Subject: Response To Request For Additional Information –  
Technical Specification Change Request No. 286,  
Emergency Feedwater Changes (TAC NO. MB3660)

Three Mile Island, Unit 1 (TMI Unit 1)  
Facility Operating License No. DPR-50  
NRC Docket No. 50-289

**RESPONSE TO REQUEST FOR ADDITIONAL INFORMATION  
TECHNICAL SPECIFICATION CHANGE REQUEST No. 286  
EMERGENCY FEEDWATER CHANGES**

FIGURE 1 (Updated)

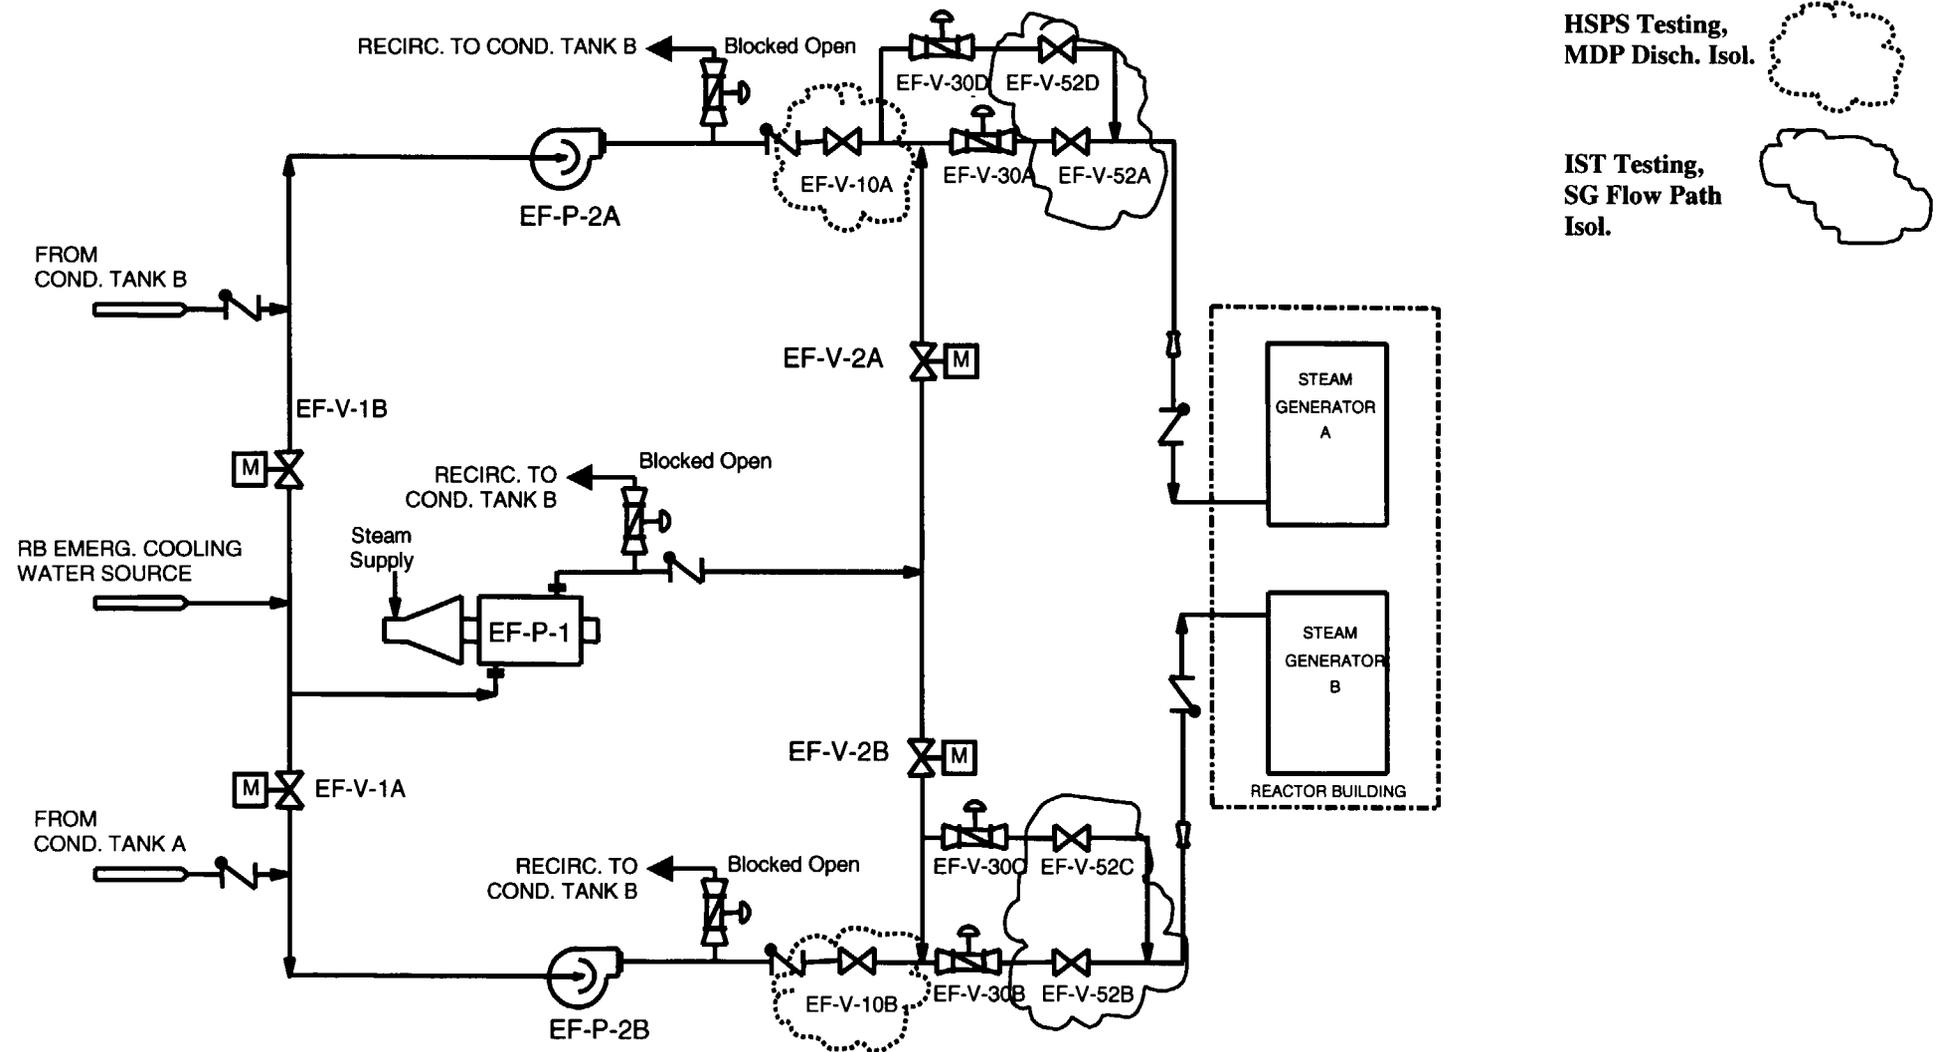
What is the minimum amount of time allowable for an individual to realign the valves to their operational positions in the event an EFW transient were to occur while performing this surveillance test? Also, please clarify: Using Figure 1 from the licensee's December 19, 2001, submittal as a basis, identify which valves require manual actions and the relative distances between them. Also, identify the transit time between valves and, how much time and effort are required for an individual to manually realign each valve.

An updated Figure 1 is provided showing the EF-V-10A/B valves. The specific valves discussed below are highlighted to aid identification.

The IST testing isolation valves (EF-V-52A/B/C/D) are located in the motor-driven EFW pump room immediately adjacent to the associated pumps. The valves associated with each steam generator are within 20 feet of each other, have no interfering appurtenances in the path of travel for an operator, and are at an elevation convenient for operator manipulation. Isolation valves EF-V-52A/D are closed during testing of EF-P-2A with all components located in the EF-P-2A cubicle. Isolation valves EF-V-52B/C are closed during testing of EF-P-2B with all components located in the EF-P-2B cubicle.

The HSPS test isolation valve EF-V-10A is located immediately adjacent to MDP EF-P-2A and valve EF-V-10B is located immediately adjacent to MDP EF-P-2B. The operator would remain in the immediate proximity of the pump during testing, moving back several feet during the pump motor start/stop for personnel safety purposes.
